Phoenix Ironworks

Design Changes Justification  
Document

PIW-PRP-ZZ-ZZ-TR-A-100003

PRP Architects have been appointed by EWC and Manchester Life Development Company to submit a Non-Material Amendment Application (section 96a) to formally approve the changes to the original planning application prepared by CallisonRTKL (now Arcadis).

Poland Street Elevation

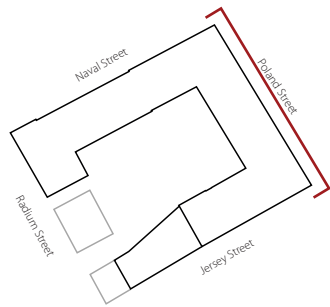
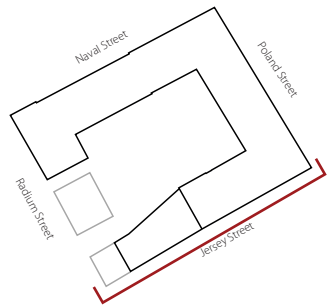
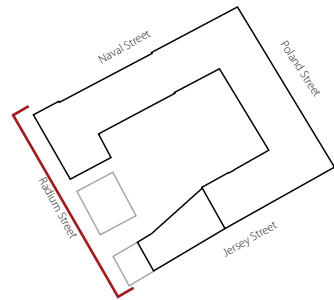
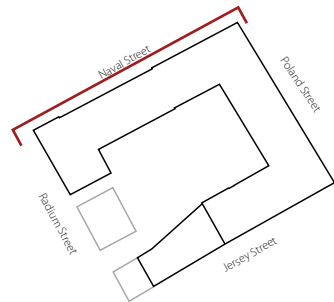
The consented design was based on a typical floor-to-floor height of 3,075 mm. The proposed design seeks to slightly reduce the overall building height by decreasing the typical floor-to-floor height to 3,000 mm.

The elevations shown on the right and the following page illustrate this reduction in building height. In our view, this adjustment does not adversely affect the building’s massing or its overall visual impact.

Please note the perimeter roof guard rail is collapsible and can be folded down when not in use, making it concealed from sight when not needed.

2.2. Core 1 extension to roof on level 9

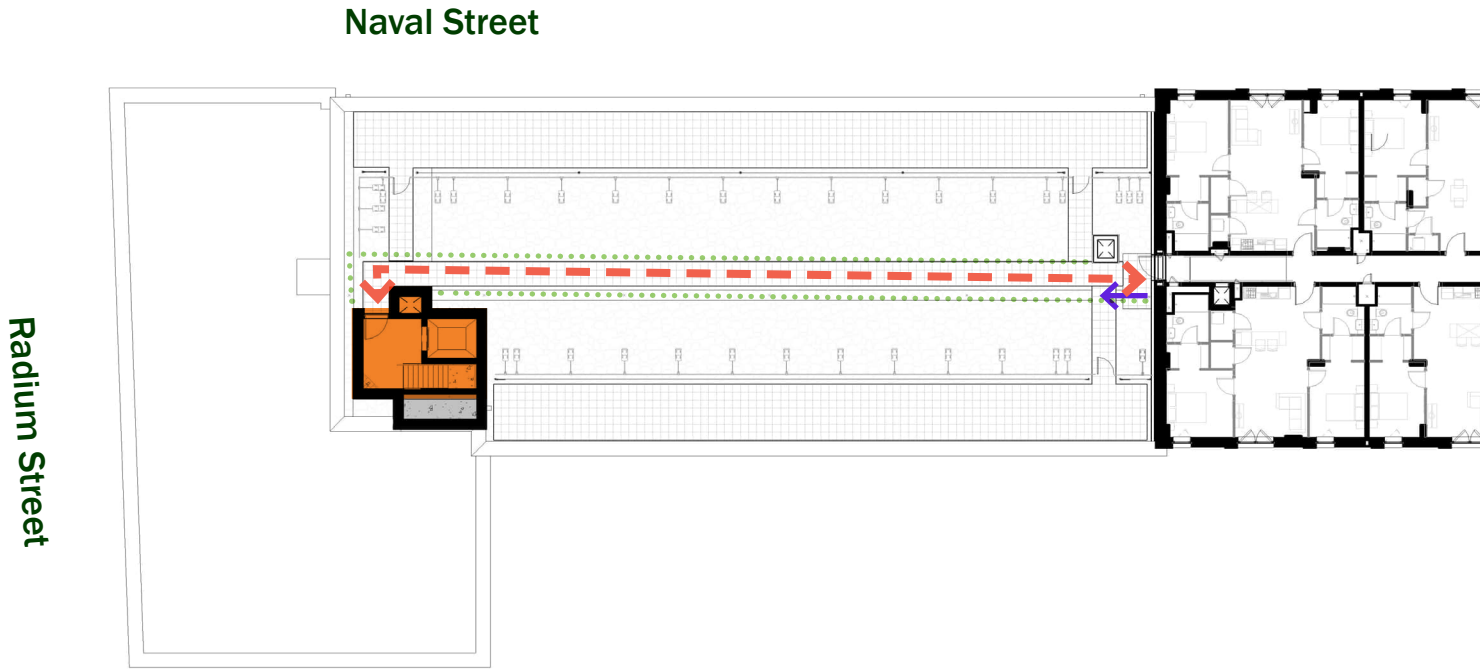
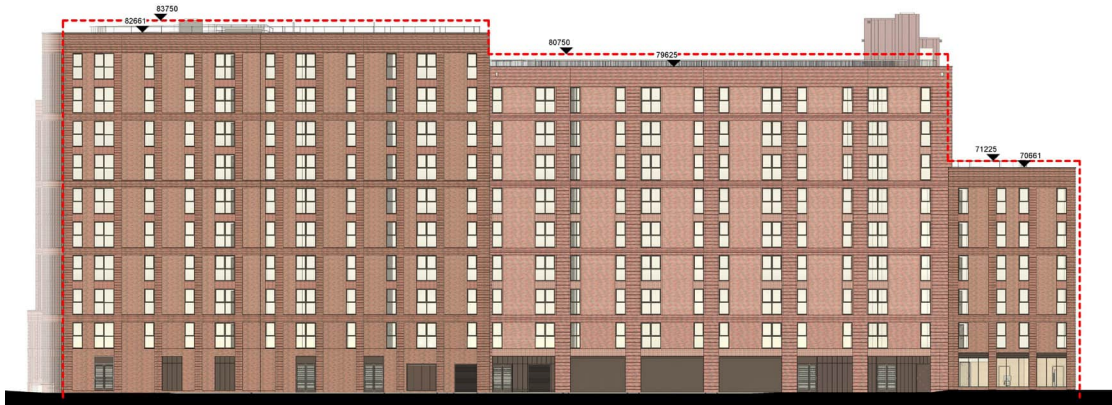
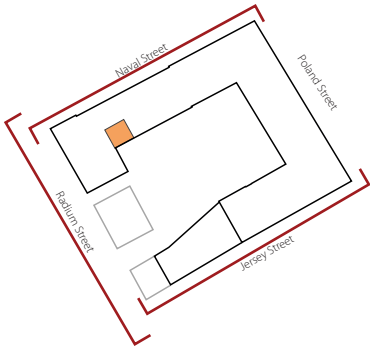
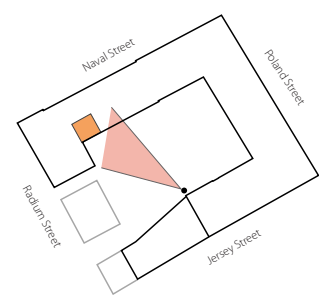
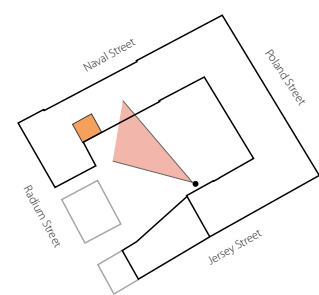
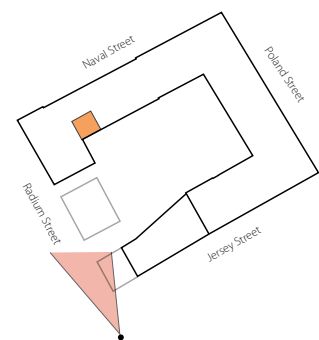
Although this does not constitute a design change to the consented scheme, we have further developed the design of the roof core extension where escape from the upper most floor is provided across the roof.

To minimise the visual impact at the roof edge, the volumes above the stair and lift overrun have been stepped back.

The small shaft adjacent to the stair overrun must extend 500 mm above the roof level due to technical requirements.

To reduce the visual impact, the walls have been clad in zinc, allowing them to complement the building's existing material palette.

Covered walkway elevation - Consented Design

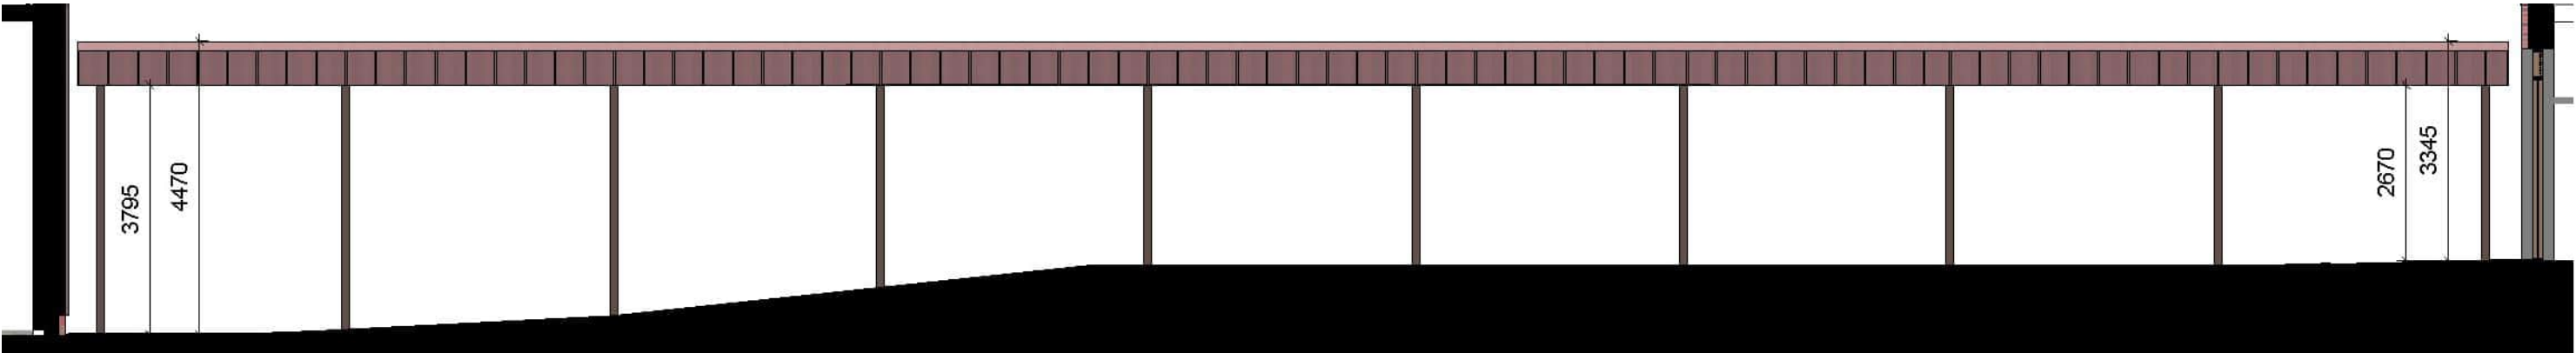
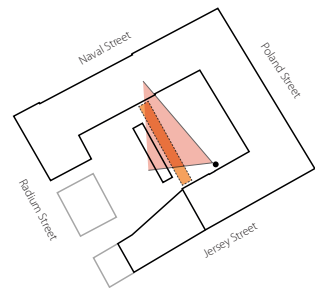
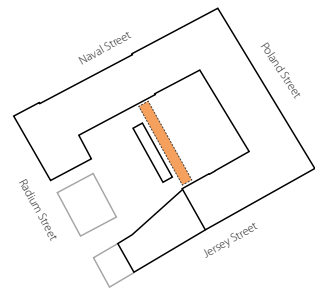
To achieve significant cost savings and support the overall viability of the project, the curtain walling has been removed from the walkway corridor linking the two blocks on Jersey and Naval Street.

The walkway will be retained as a separate external structure with a solid roof, maintaining connectivity between the two residential blocks.

Additionally, a railing and gate will be installed at the rear of the private makers' units to provide a secure boundary to the private gardens.

View from public internal courtyard - Consented Design

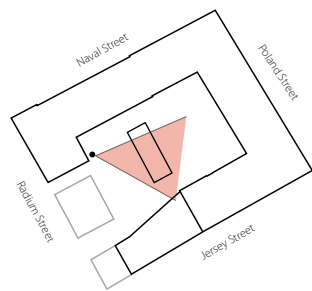
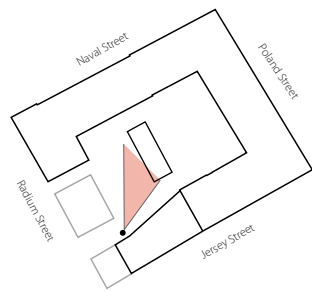
The design of the private makers units within the courtyard has been refined from the original planning approval to offer a small saving towards project viability, we have retained the approved façade materials and distinctive saw-tooth roof form, while making only minor adjustment to reduce the roof pitch and overall ridge height without compromising the architectural intent or character of the scheme.

Consented design: Poland Street Elevation

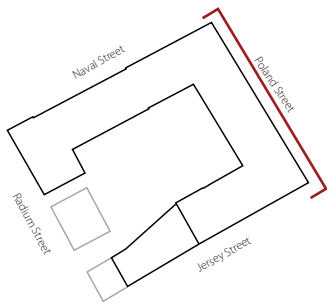
As part of the design development, the building’s external envelope has been evaluated. To achieve the required thermal performance standards, the roof build-up depths have been increased, resulting in a corresponding rise in window cill levels at the ground, and second floors where they interface with set-back roofs.

Additionally, detailed surveys of the surrounding terrain and adjacent roads revealed conflicts between the consented design’s window locations and the existing topography. To resolve these issues, smaller windows have been introduced.

Consented design: Window transom height 875mm

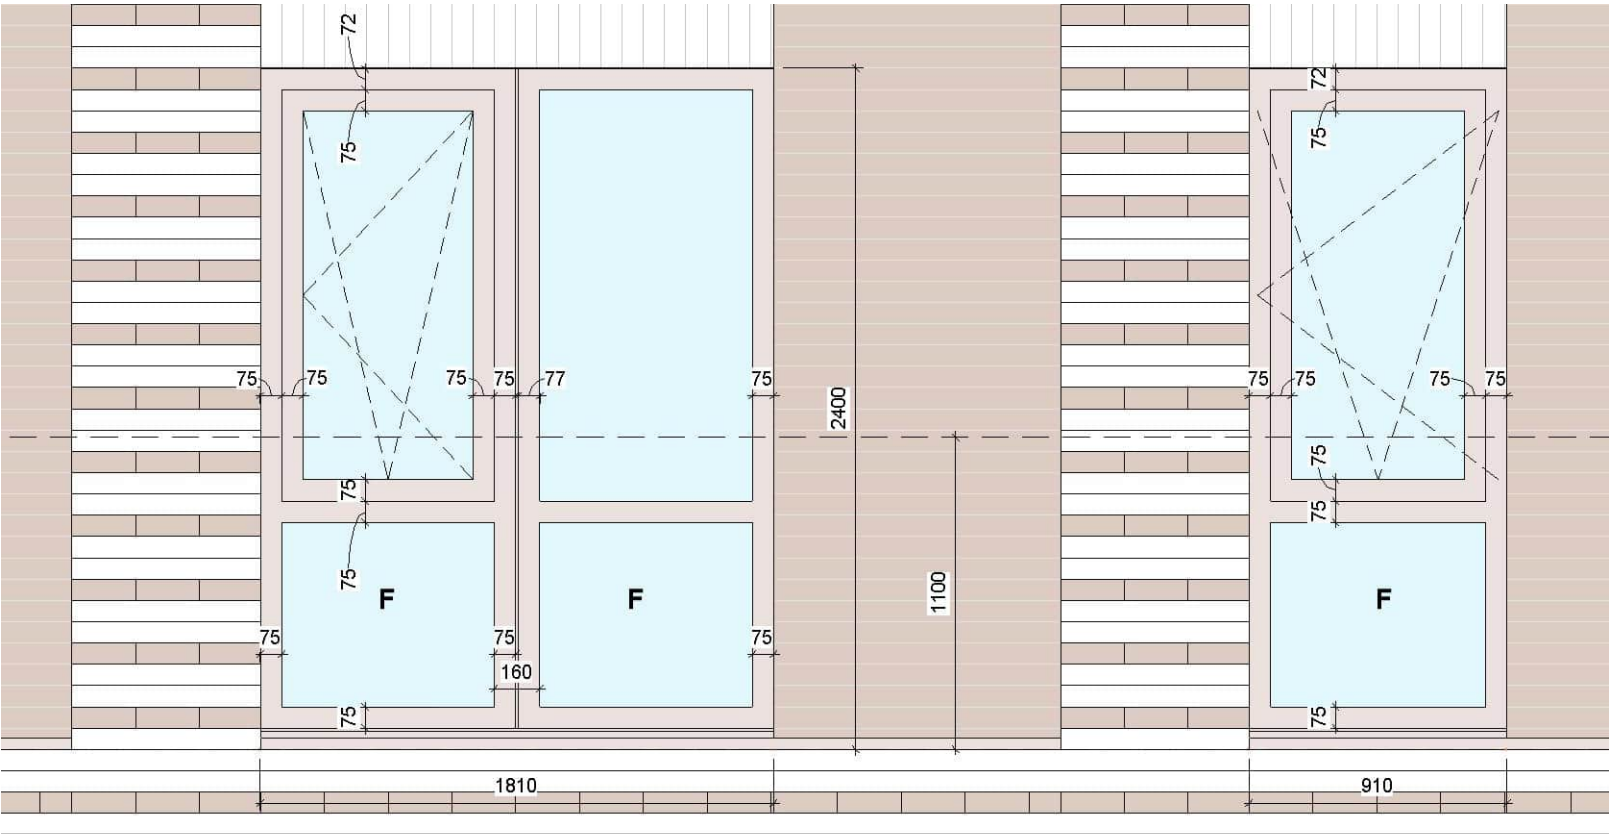
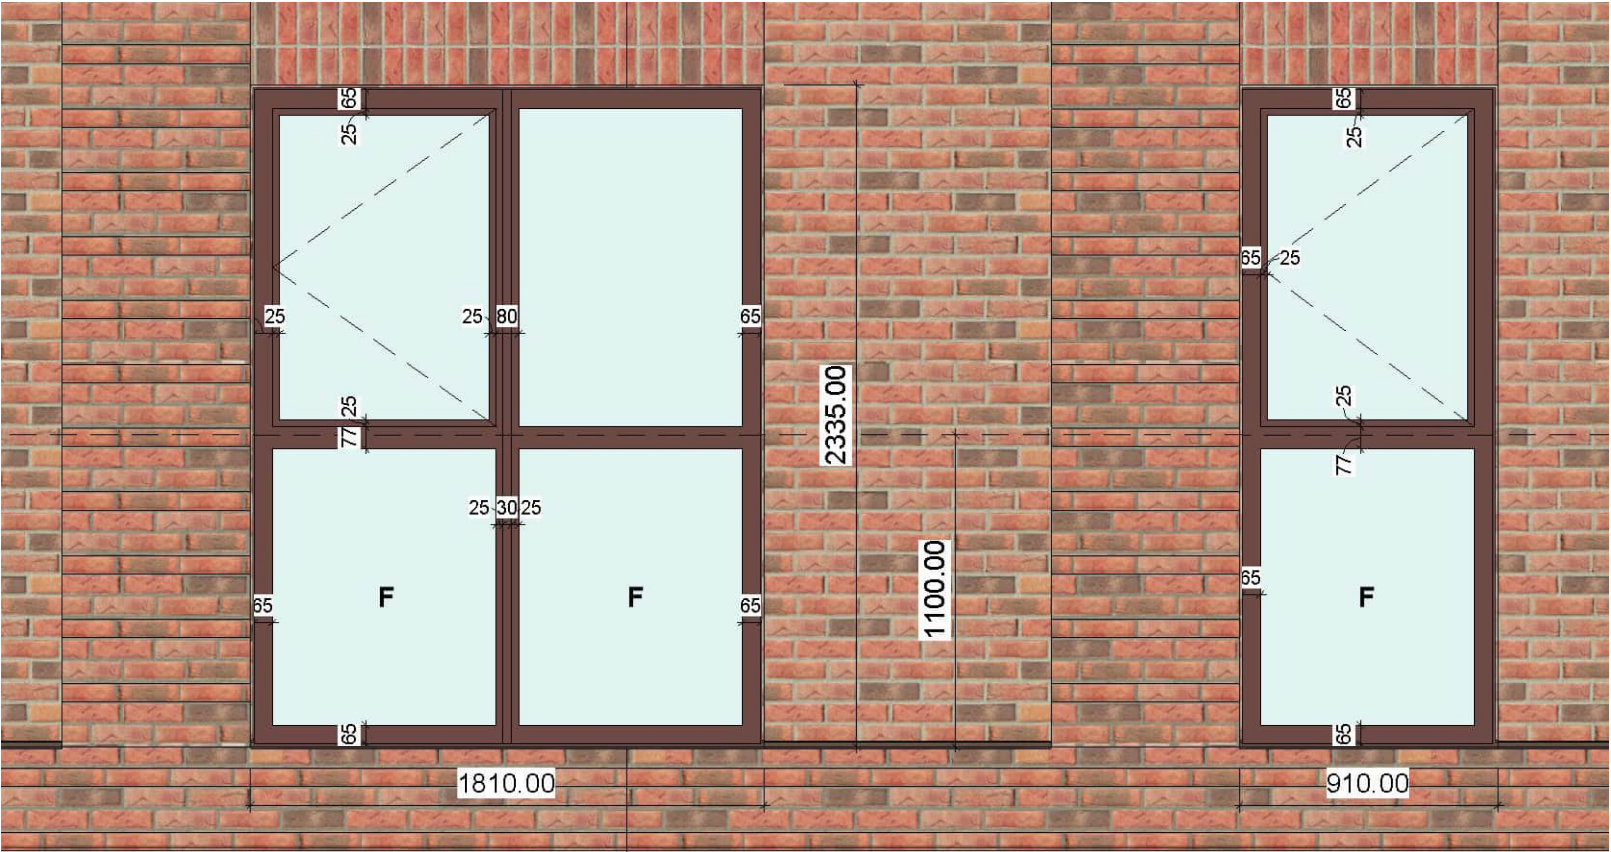
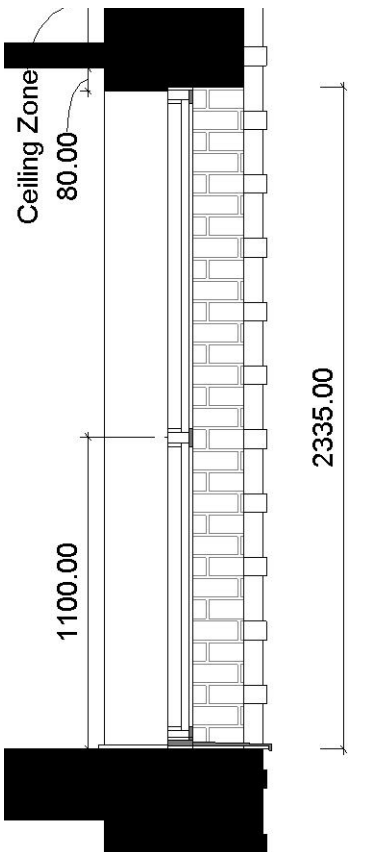
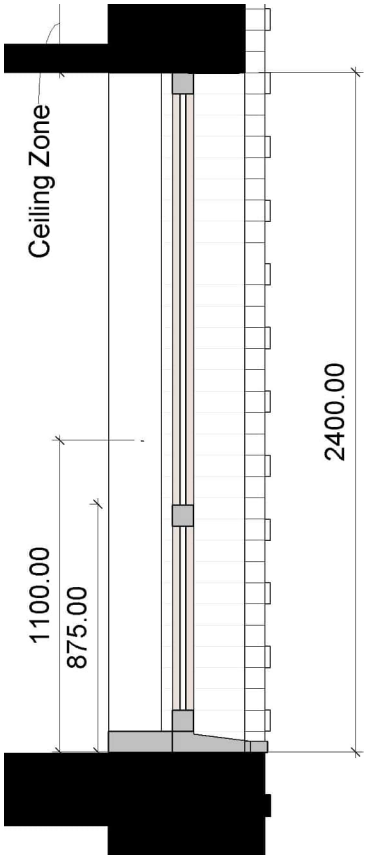
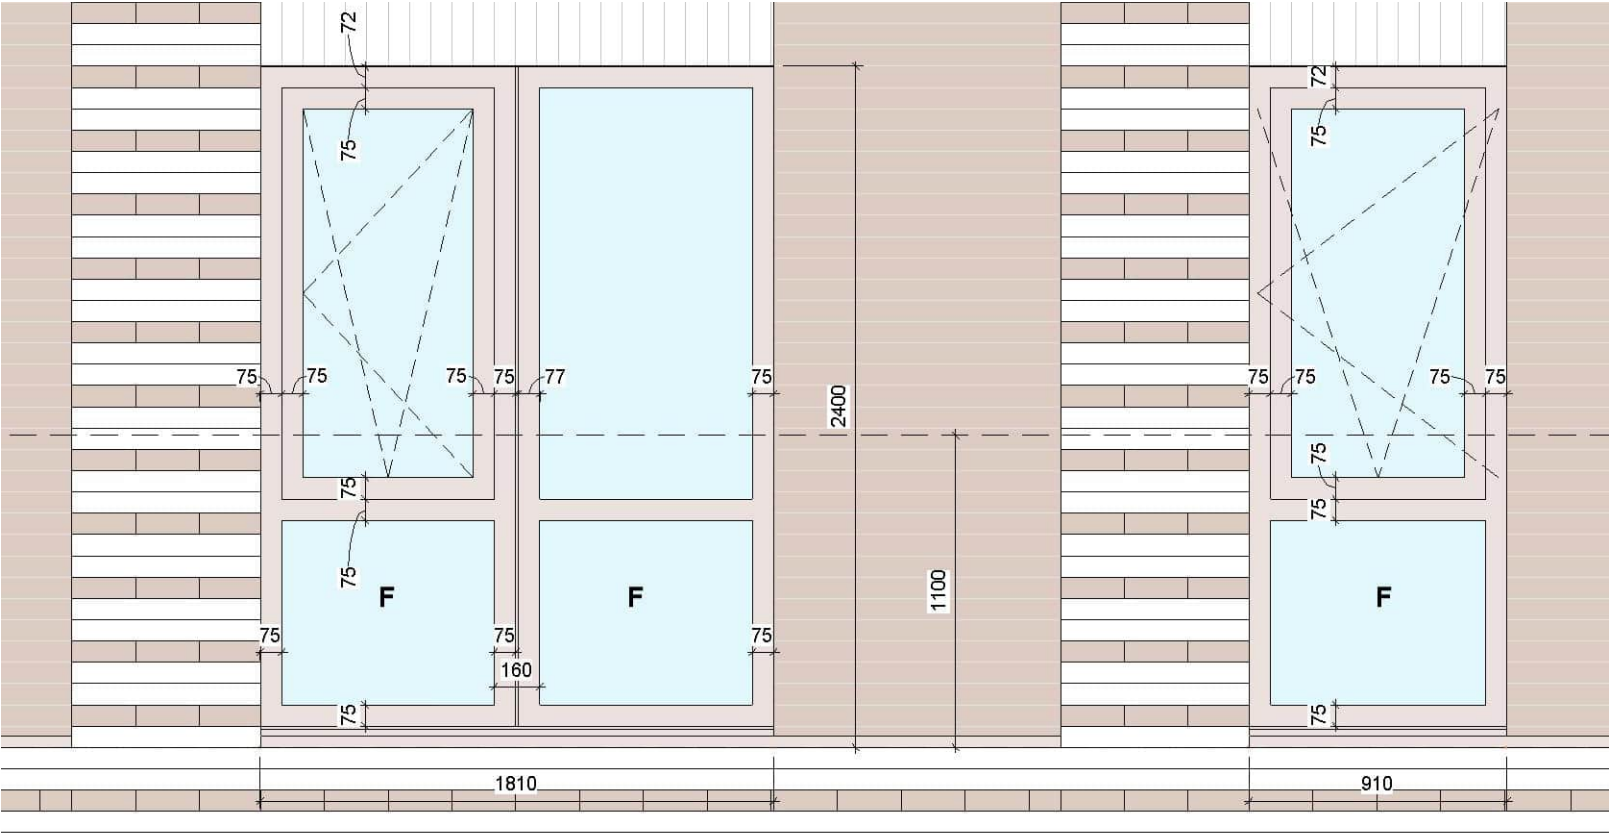
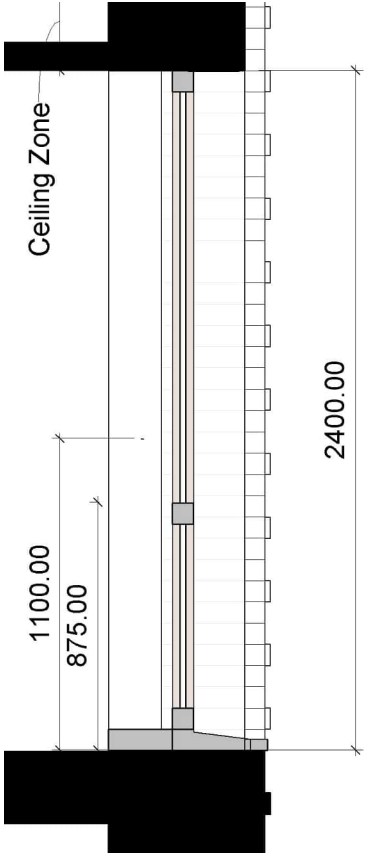
To comply with the updated requirements of Approved Document Part O, window transoms have been raised to a height of 1,100 mm.

This adjustment is necessary to provide the required protection against falls when windows are open, ensuring the safety of building occupants.

Consented design: Brick projection detail 20mm

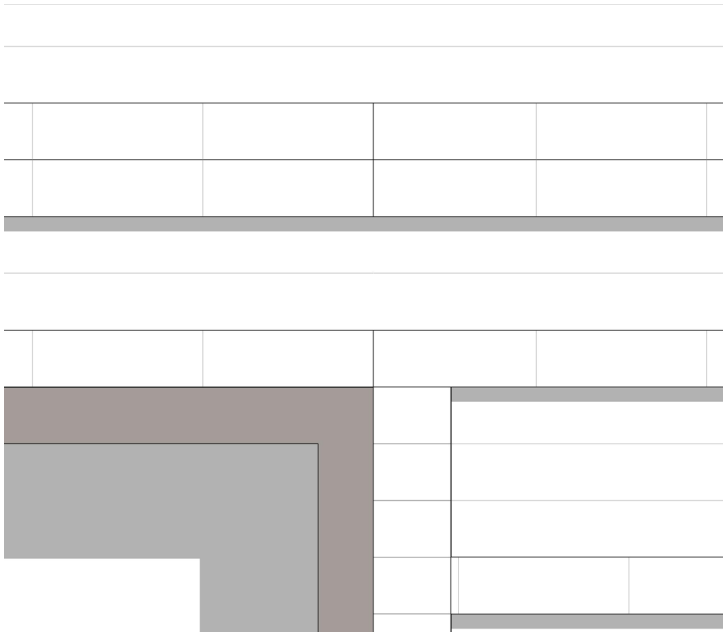
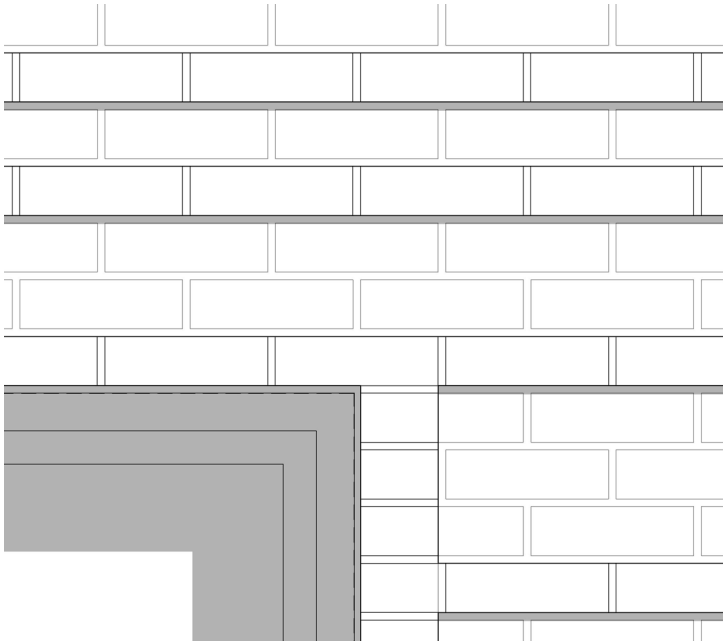
The consented design included a 20mm projecting brick detail. However, projections of this depth can lead to technical issues, particularly in relation to water management and long-term durability.

Deep projections are more susceptible to water accumulation and increased exposure to driving rain, which can result in water ingress, staining, frost damage, and accelerated deterioration of mortar joints.

To address these concerns and improve weathering performance, the projection has been reduced to 12mm maintaining the intended architectural detail while mitigating the risk of moisture-related issues.
